Mountain View Cemetery Expansion Project

Response to Comments / Final Environmental Impact Report

Lead Agency: City of Oakland

City Case # PCN15048 – ER01

Figure 12-6
Revised Project - Additional Tree Protection
Plot 98

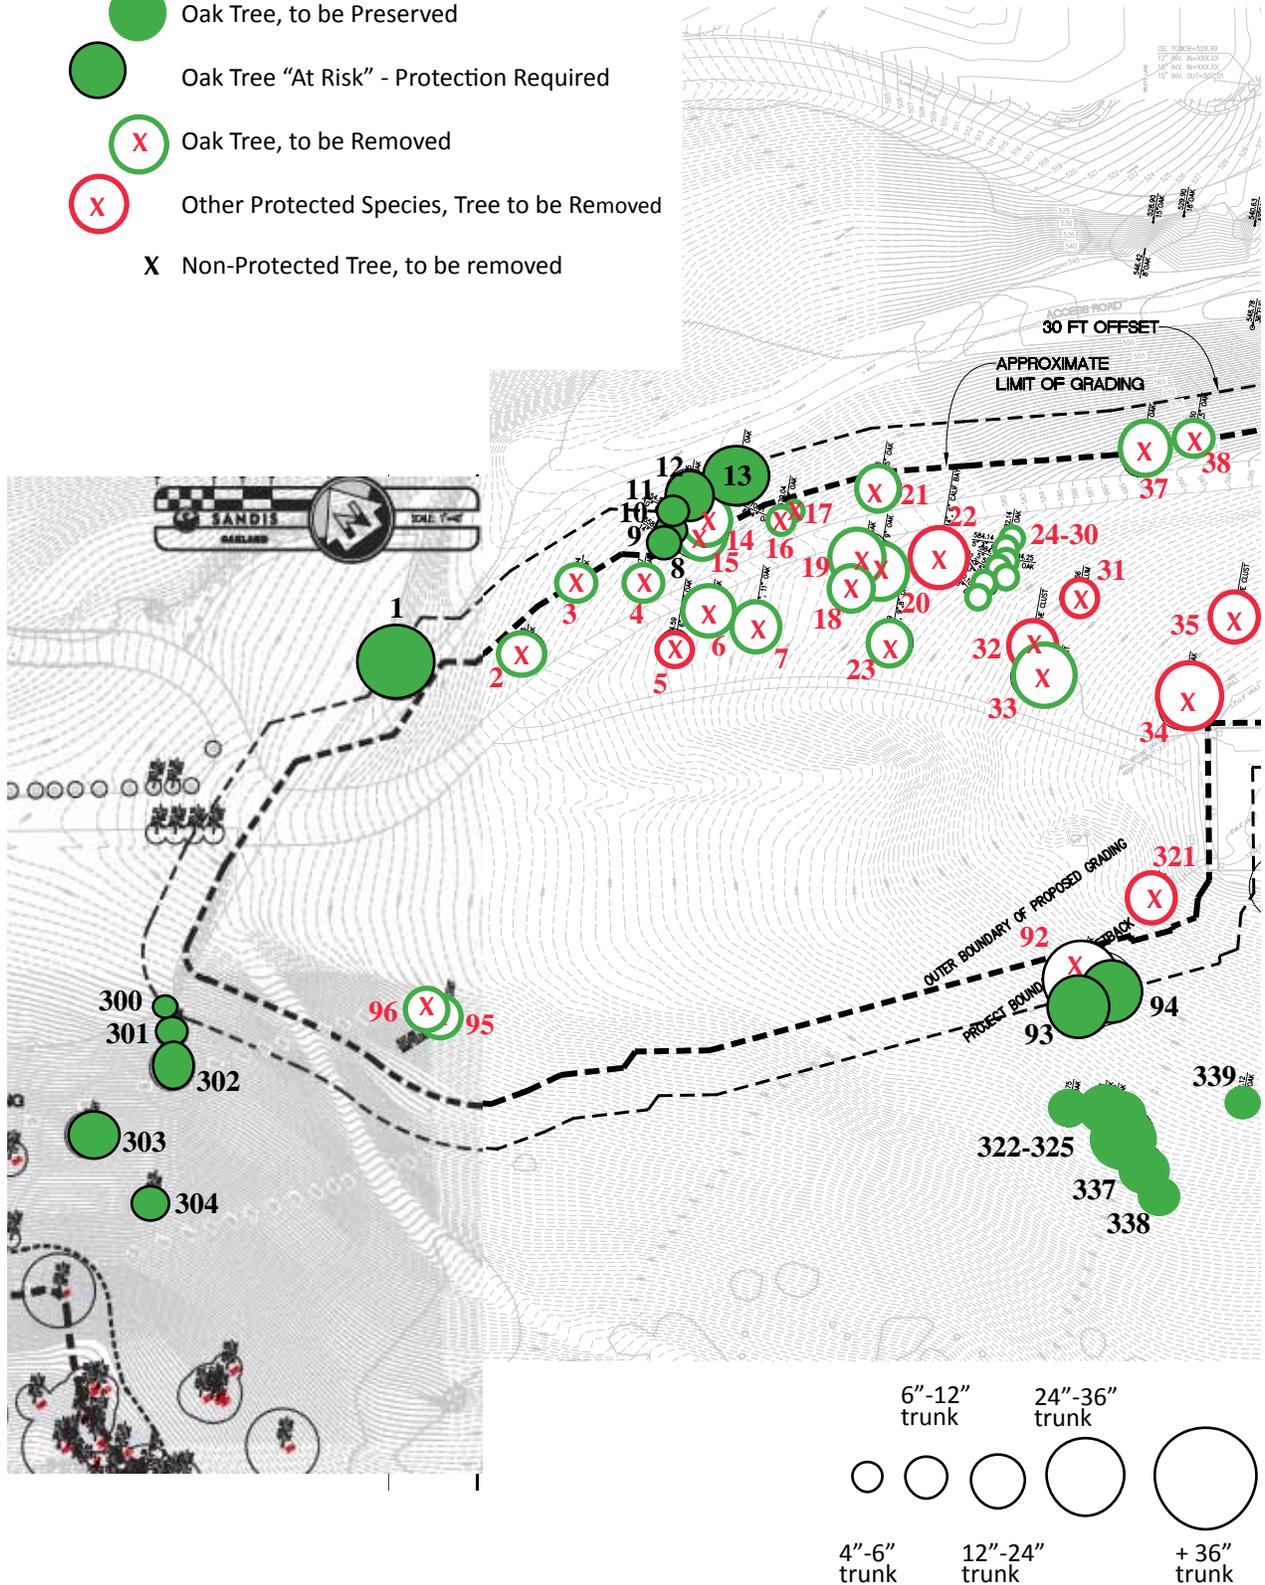
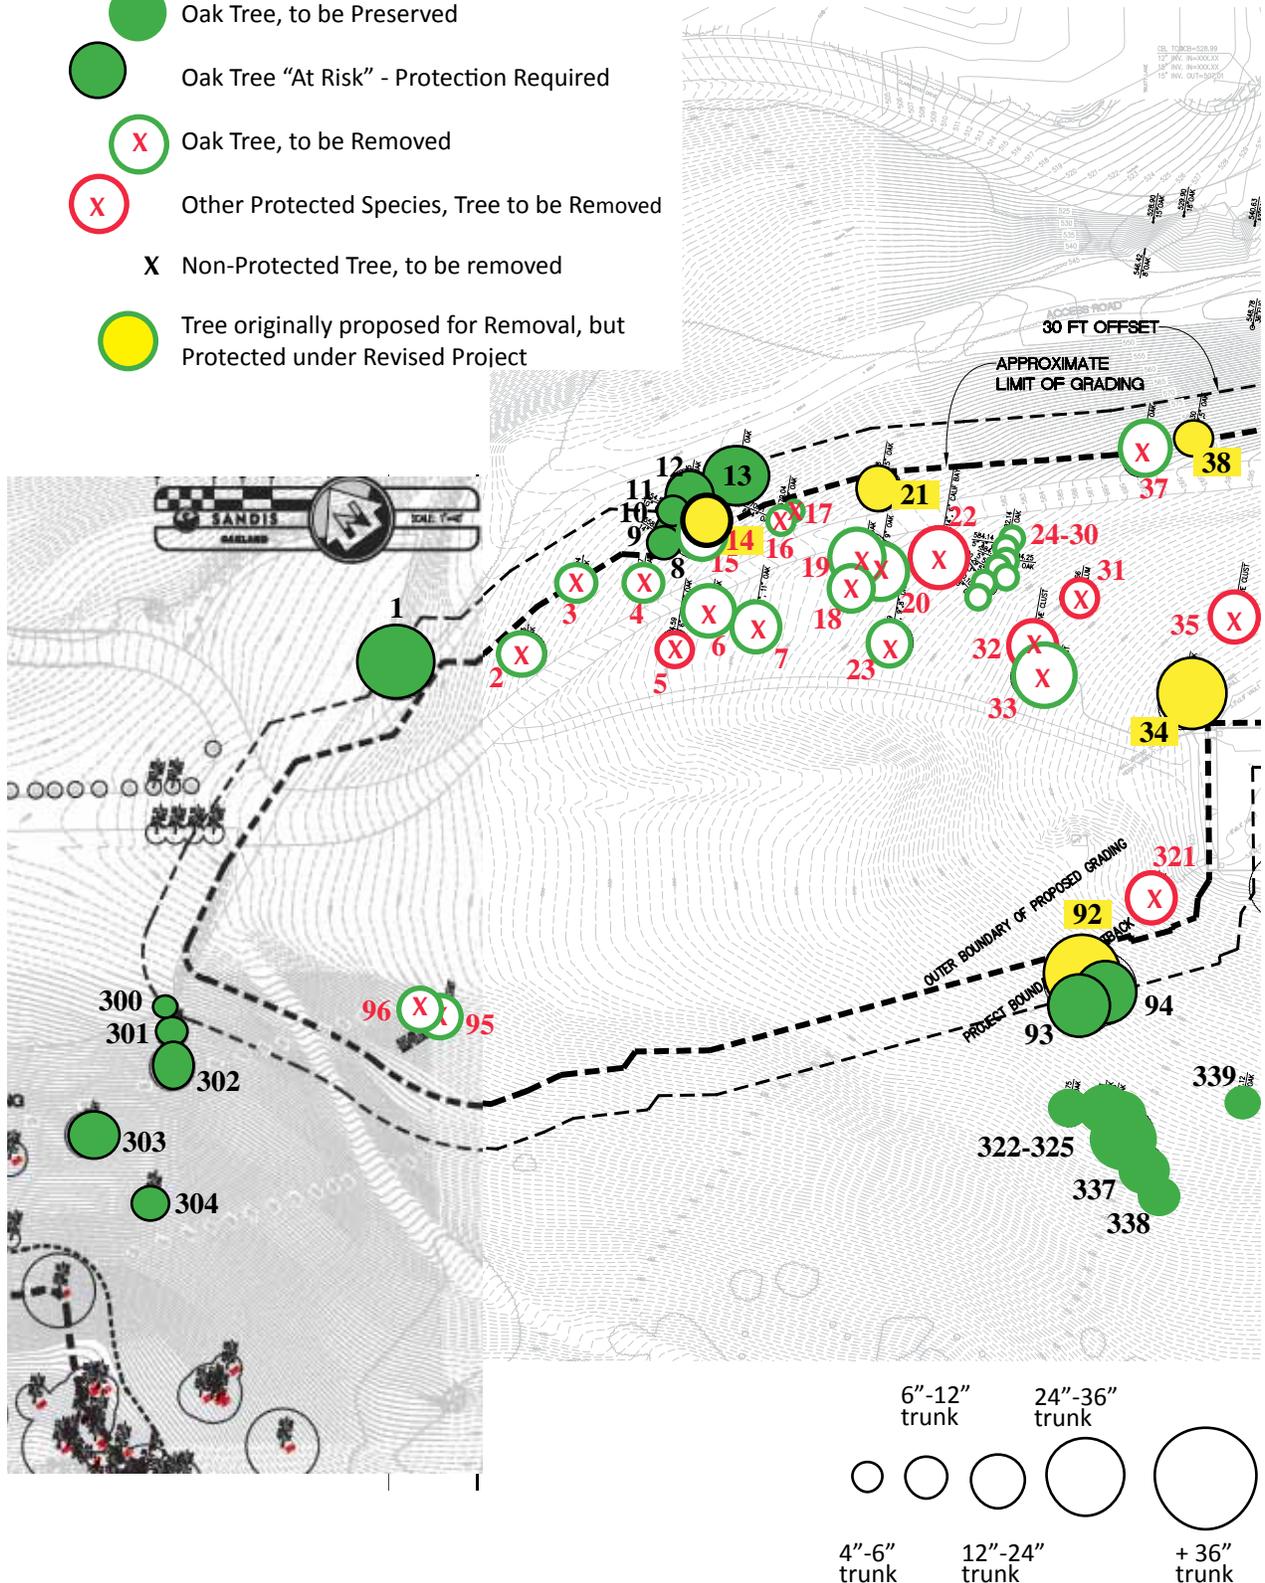
The Revised Project now incorporates a design strategy that shows the retaining walls below Plot 98 and a portion of the Panhandle as being uphill from, and protective of several trees along this lower edge of the site. In addition to those trees #80-82, 84, 88, 93-94, and 326-329 that were shown in the Draft EIR as being “At Risk” and in need of protection (but not removed), the Revised Project now indicates that four additional trees (#34, 85, 86, 87 and 92) can be preserved with minor modifications to the downhill edge of grading in this area.
